RECEIPT DATE: 11/17/15 **ONSITE SEWAGE DISPOSAL SYSTEM** P 557459

PROPERTY ADDRESS: 15250 Sweetbay Street, Woodbine, MD 21797

RE: Belle Haven Estates, Lot # 40 and Lot #30
BAT Plan and Building Plan

SITE PLAN FOR BAT INSTALLATION

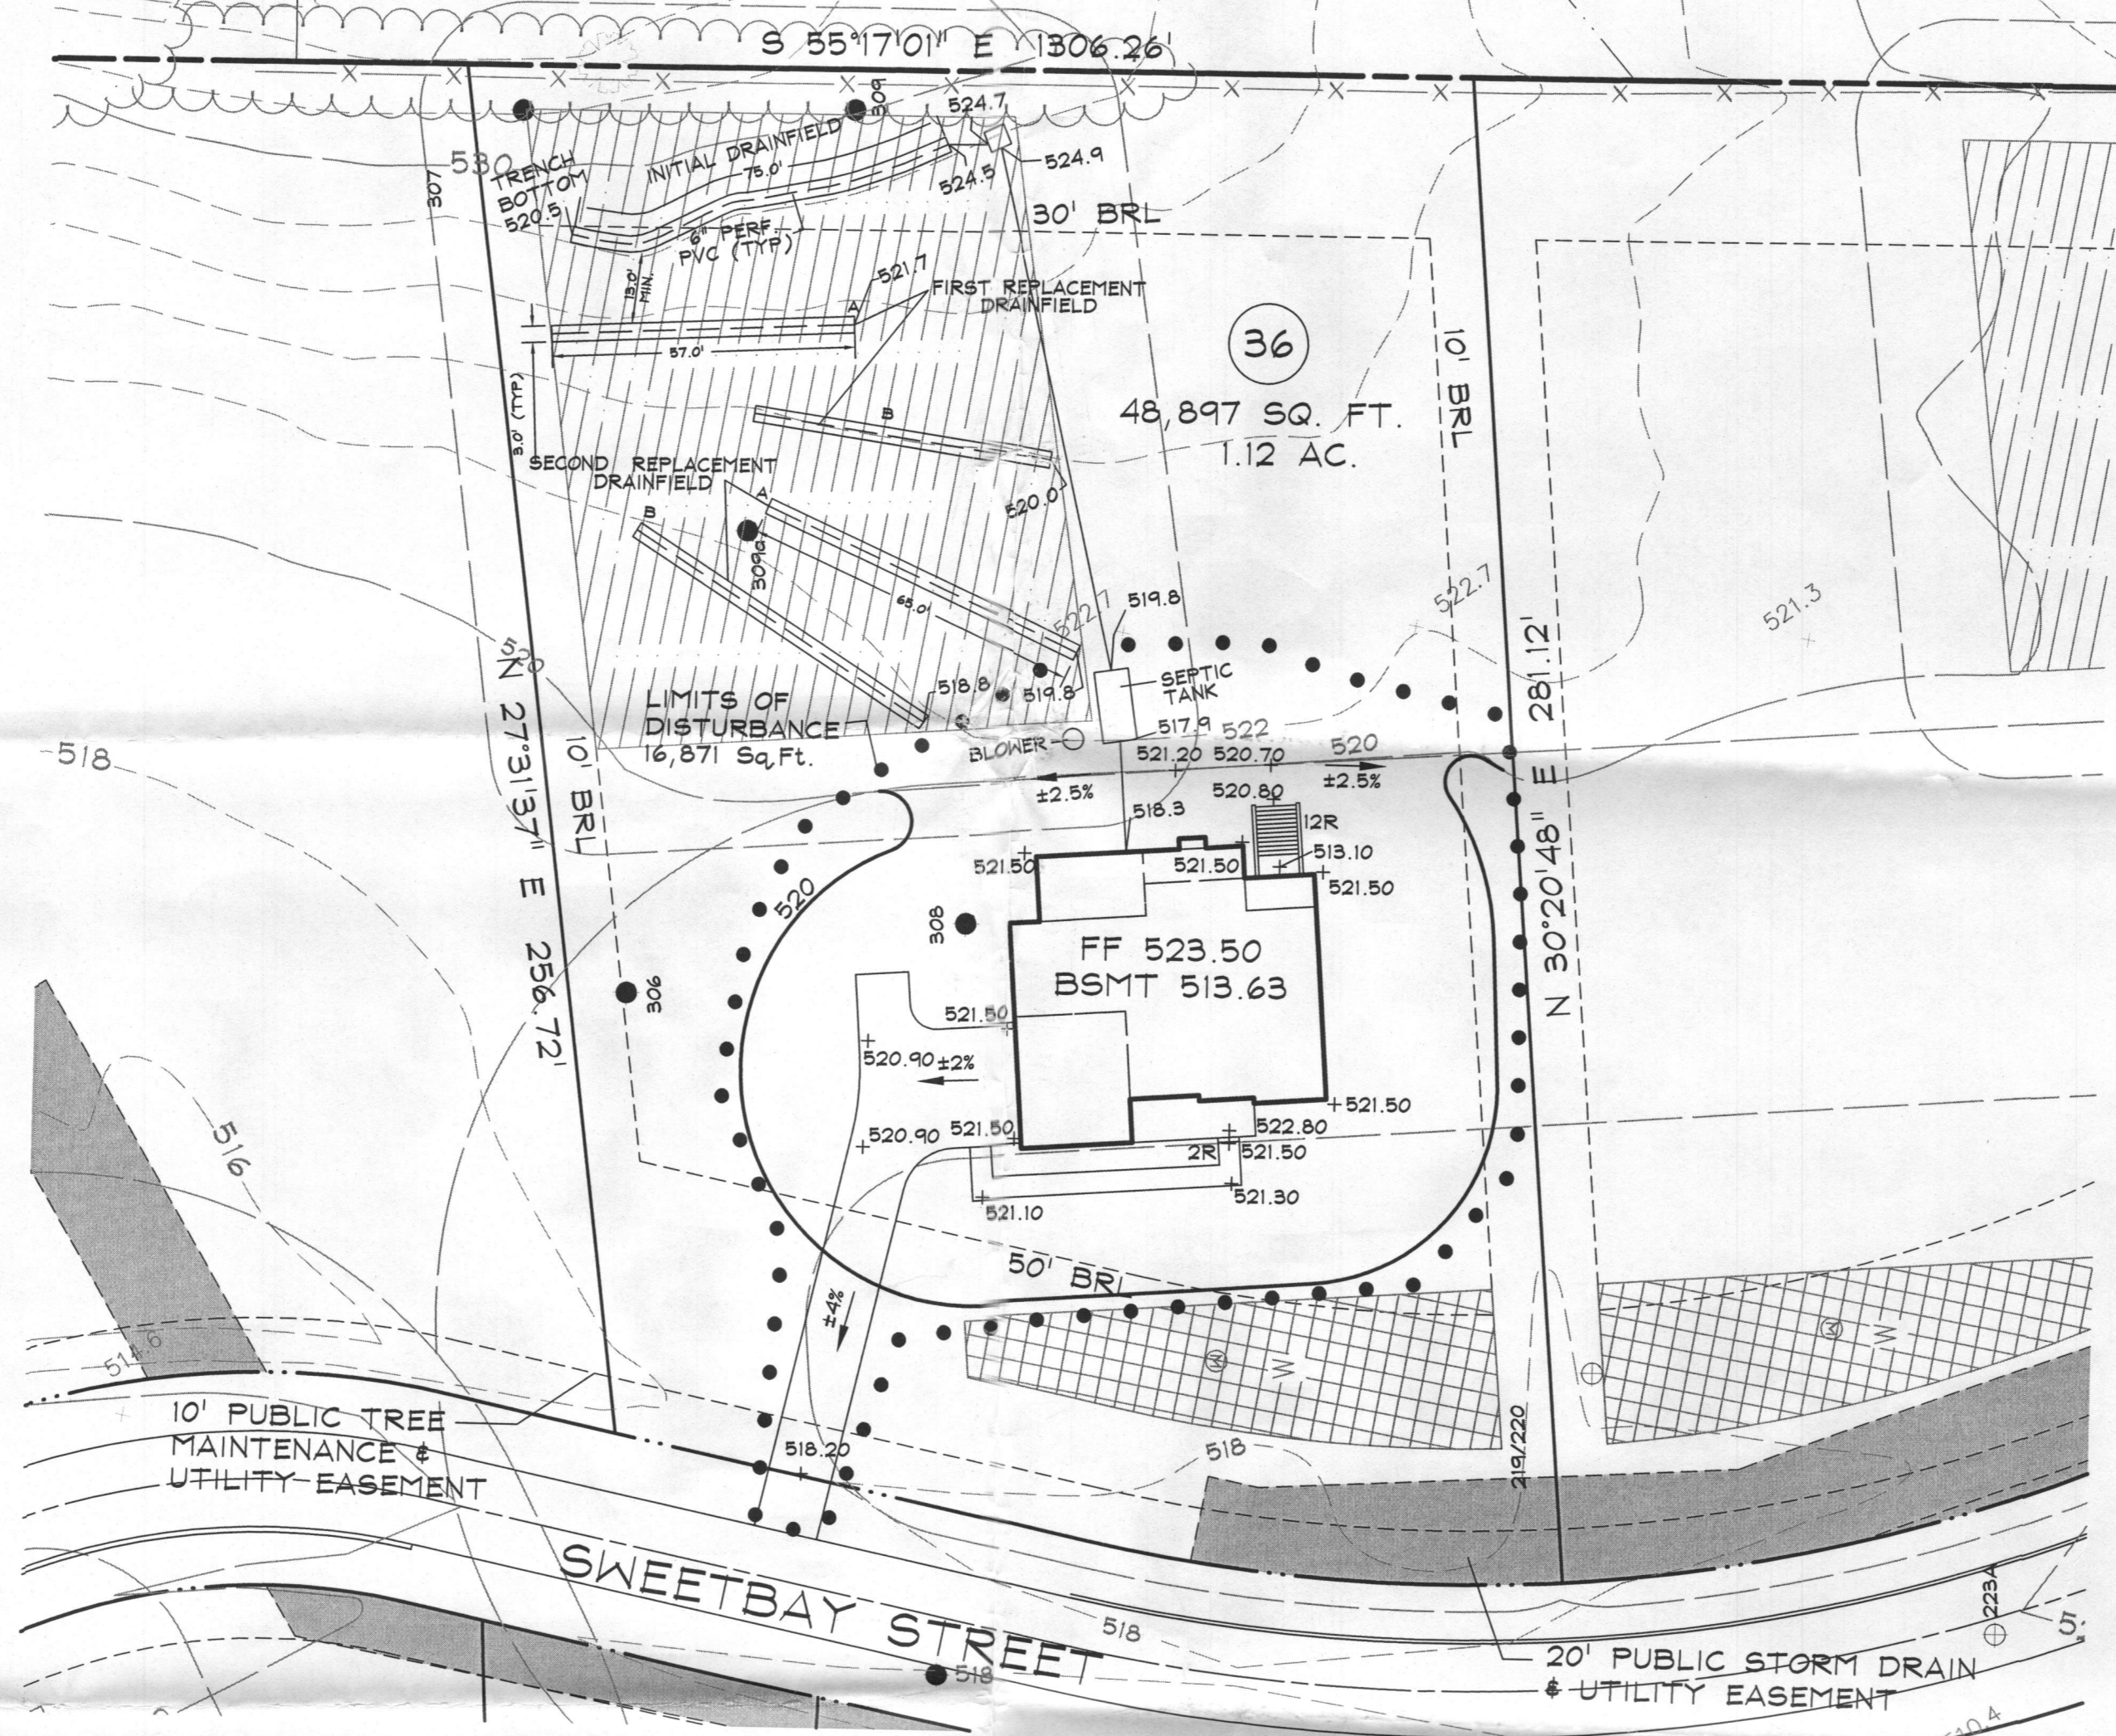
BAT Plan

- Show the location of the initial absorption system and 2 replacements with perforated pipe elevations. All trenches should be equal in length and **on contour**. We prefer that all trenches are no longer that 50 feet \pm 5 feet. This layout will allow more room for future replacements. Example:

- Your building site plan must show the location of the initial absorption system and 2 replacements with perforated pipe elevations. All trenches should be equal in length.
